**Application for Waiver from Construction Standards for Public Water Systems**

Water System Name	Roco Winery & Tasting Room	PWS ID	TBD
Project or Facility	Buried 3,250-gal Norwesco tank model#3525	County	Yamhill
Need for waiver identified:	<input type="checkbox"/> Water System Survey	Date of Survey	N/A
	<input checked="" type="checkbox"/> Plan Review # 13-2026

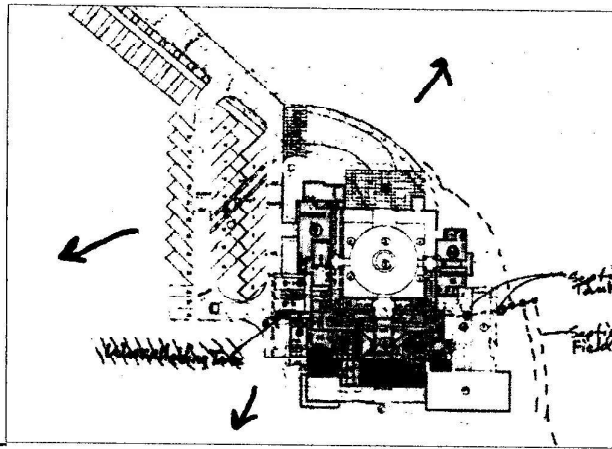
Describe why meeting the standard is highly burdensome or impractical. The only access to the inside of the buried 3,525-gallon potable water storage tank is through the roof hatch as shown in the photographs below. Installing a permanent ladder would be difficult given the small access hatch and piping (shown below). Installing a footing drain, tank drain and overflow would also be difficult.

Describe proposed alternate measure that provide adequate protection to public health and safety. The tank would be pumped out if we ever had to drain or clean out the inside of the tank, avoiding the need for a drain or for a ladder to enter the tank. The tank has level controls that prevent the tank from overflowing. The tank access has a lid and is secured with tamper resistant security screws to prevent unauthorized access. The location of the tank is also not generally accessible to the public. Tank is located on a hill above water table and grade slopes away.

Plan Review Coordinator's notes: The alternate measures provided should be adequate for normal operation of the storage tank.
